ENCLOSURE 1  
TO SERIAL NLS-85-129

PROPOSED TECHNICAL SPECIFICATION PAGES  
BRUNSWICK-1

### SUMMARY LIST OF REVISIONS

FIGURE 3.2.1-7

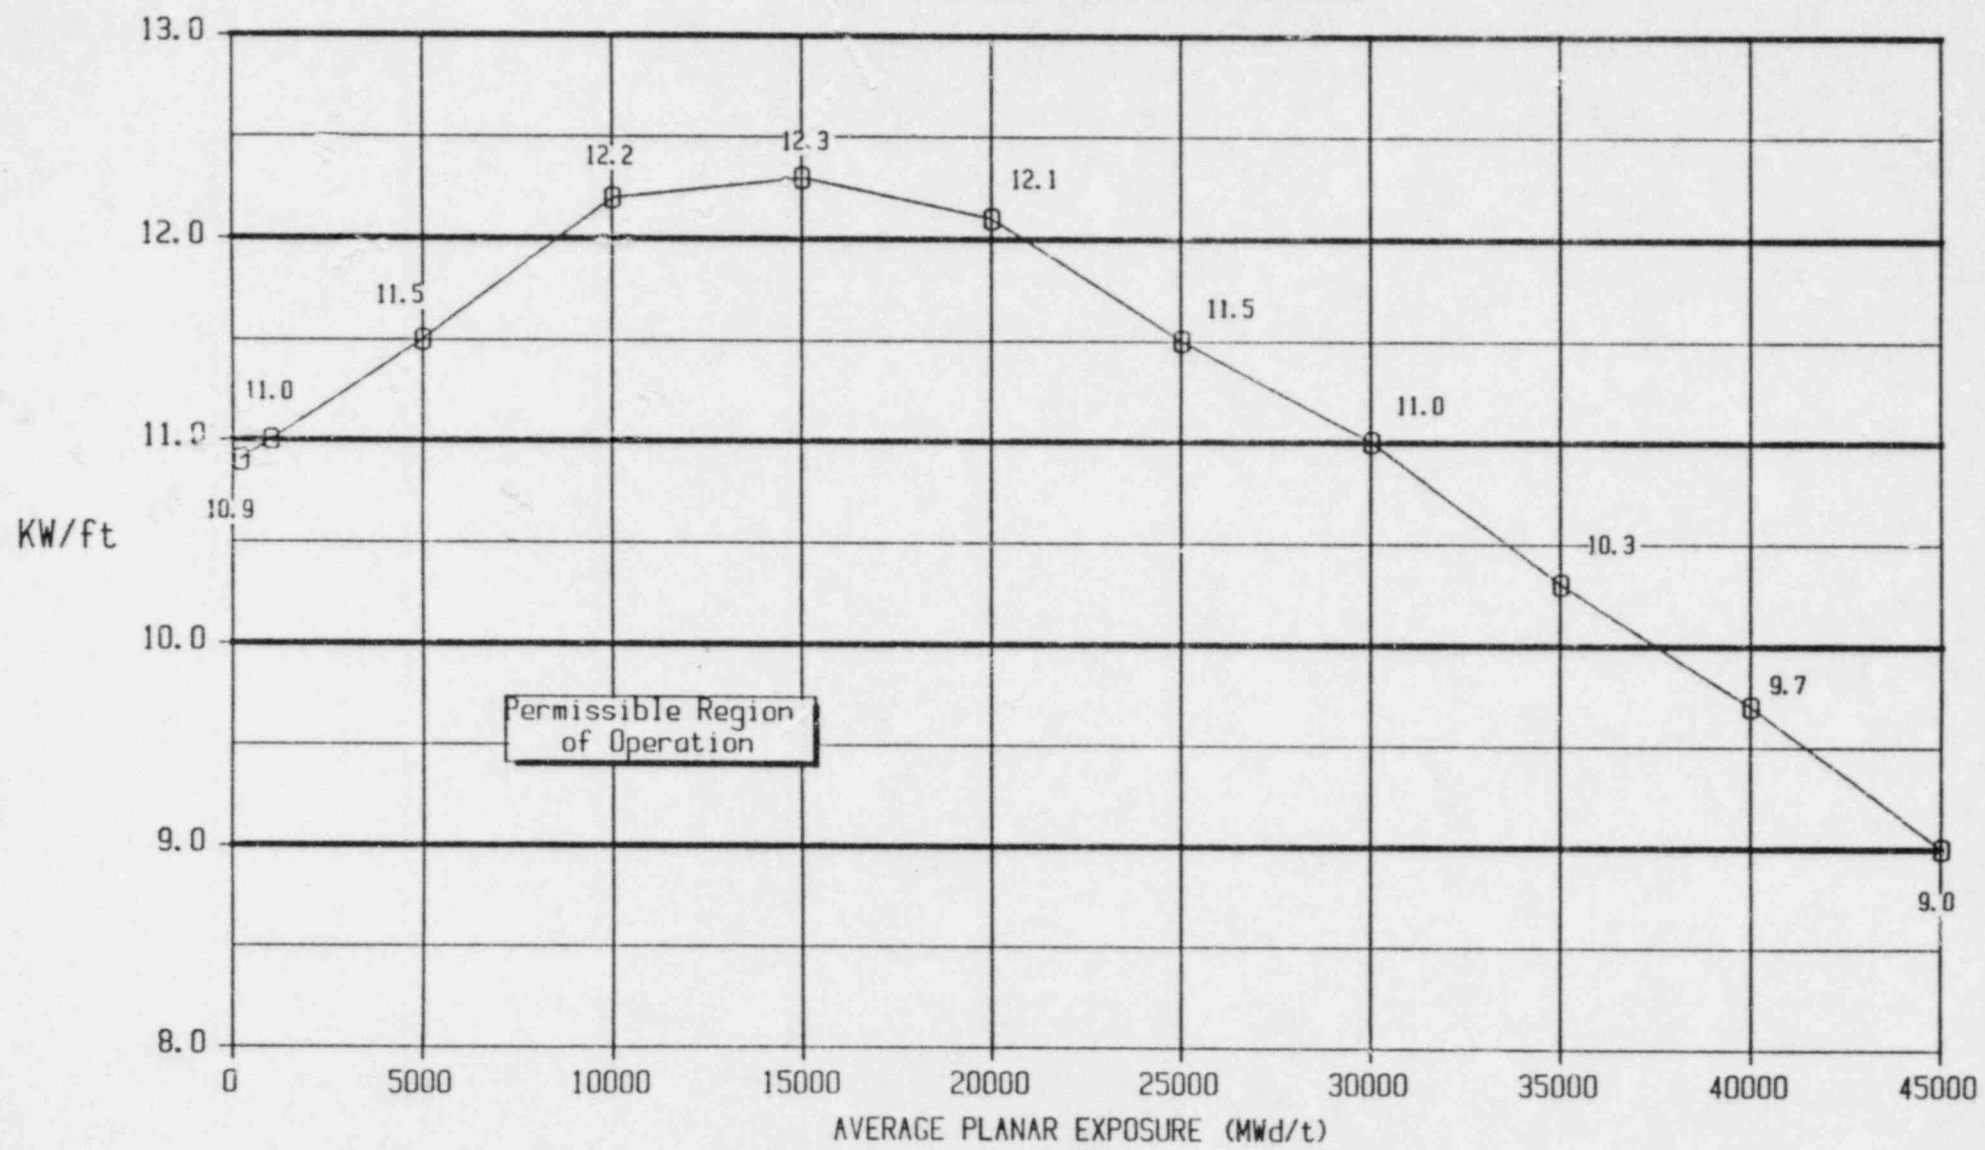
<u>PAGE NUMBER</u>	<u>DESCRIPTION OF CHANGE</u>
3/4 2-2	Graph of MAPLHGR vs. Average Planar Exposure for Fuel Type 2 (8 x 8) has been deleted. Proposed page is repaginated and Figure No. revised.
3/4 2-3	Repaginated. Figure Number revised.
3/4 2-4	MAPLHGR values corresponding to Planar Average Exposures of 35000 and 40000 MWd/t added. Repaginated. Figure No. revised.
3/4 2-5	MAPLHGR values corresponding to Planar Average Exposures of 35000 and 40000 MWd/t added. Repaginated. Figure No. revised.
3/4 2-6	Repaginated. Figure No. revised.
3/4 2-7	MAPLHGR value corresponding to Planar Average Exposure of 45000 MWd/t added. Repaginated. Figure No. revised.
3/4 2-8	New graph of MAPLHGR vs. Average Planar Exposure for the new BP8 x 8R fuel added.
3/4 2-9	Reference to 8 x 8 fuel deleted and BP8 x 8R fuel added.
3/4 2-10	MCPRs revised. Reference to 8 x 8 fuel deleted and BP8 x 8R fuel added.
3/4 2-14	MCPRs revised. Reference to 8 x 8 fuel deleted and BP8 x 8R fuel added.
